APPLICATION NO.	FILING DATE	FIRST NAMED INVENTOR	ATTORNEY DOCKET NO.	CONFIRMATION NO.
10/771,538	02/05/2004	Kazuya Midorikawa	H0314T	2812
7590	04/27/2005		EXAMINER	
Takeuchi & Takeuchi 1700 Diagonal Road Suite 310 Alexandria, VA 22314			DUVERNE, JEAN F	
			ART UNIT	PAPER NUMBER
			2839

Office Action Summary	Application No.	Applicant(s)
	10/771,538	MIDORIKAWA ET AL.
	Examiner	Art Unit
	Jean F. Duverne	2839

DETAILED ACTION

Fig.6

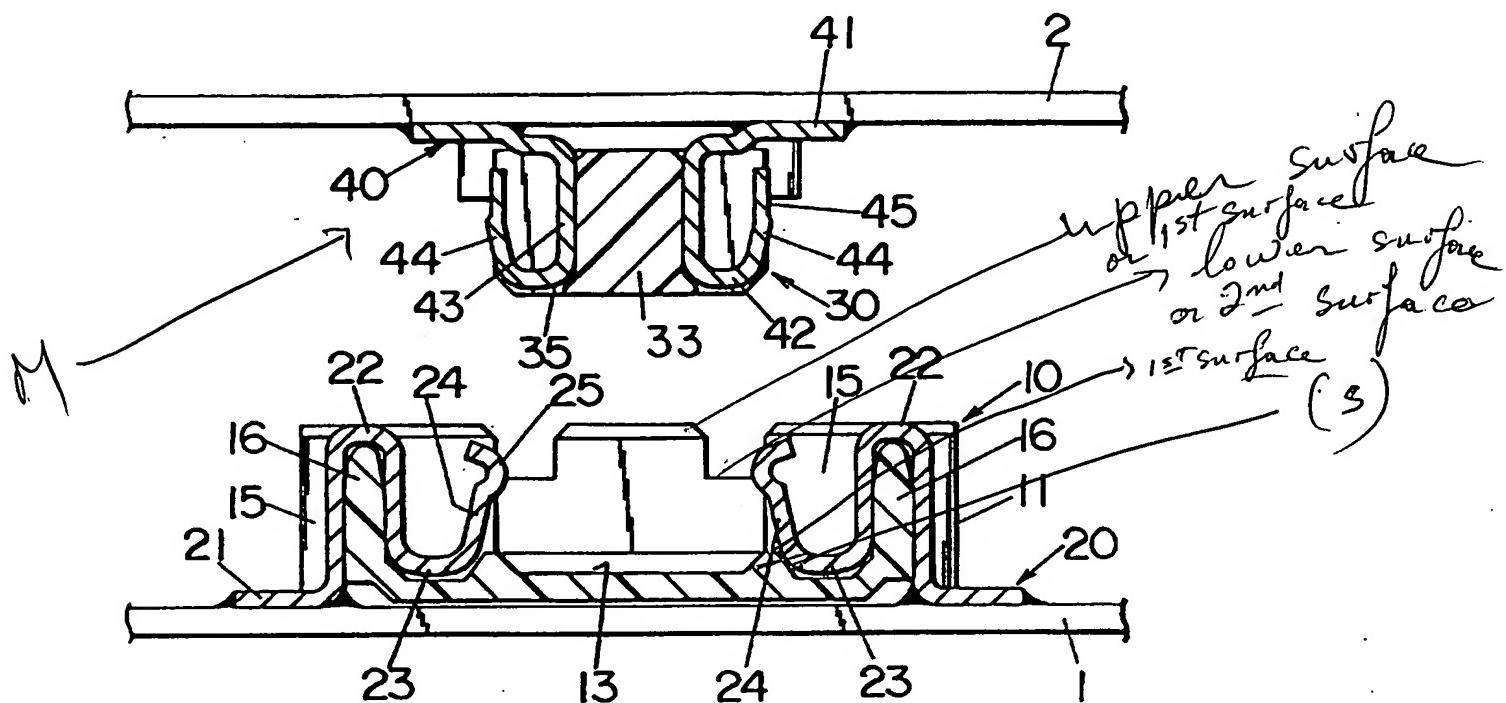
Okura's device discloses an electrical connector comprising: a substantially rectangular peripheral wall (11, 15) having an upper face (see attachment); a receiving space at 16 for receiving a mating connector (M: see attachment), said receiving space being surrounded by said peripheral wall (11, 15, 16); and a plurality of terminals at 24 with resilient contacts arranged in a pair of opposed walls of said peripheral wall, wherein said upper face of said peripheral wall includes a first surface (see attachment) in at least part of an outside area of said peripheral wall, a second surface(see attachment or at 13) in at least part of an inside area (33) of said peripheral wall, said second surface being positioned lower than said first surface, and a slant surface with a tapered shape (S: see attachment) a transit area between said first and second surfaces of said upper face; wherein said second surface of said upper face is substantially perpendicular to a plugging direction of said mating connector into said receiving space; which further comprises a plugging protrusion in said one engaging means a side surface thereof to engage said mating connector; wherein each of said terminals has a resilient contact portion, which is wound toward a bottom of said receiving space to provide a bent portion such that when said mating connector is

brought into contact with said bent portion, said resilient contact portion is resiliently flexed in a direction substantially perpendicular to a plugging direction of said mating connector (which is an inherent and obvious limitation).

Okura's device discloses the aforementioned limitations including the click projection at 26 and 27. However, Okura's device fails to explicitly disclose the projections near the contact portion. It would have been obvious to one having ordinary skill in the art at the time the invention was made to place the projections near contact portion, since it has been held that rearranging parts of an invention involves only routine skill in the art. In re Japikse, 86 USPQ 70. It would have been obvious to one having ordinary skill in the art at the time the invention was made to place the projections near contact portion in order to improve the retention and the reliability in Okura's device.
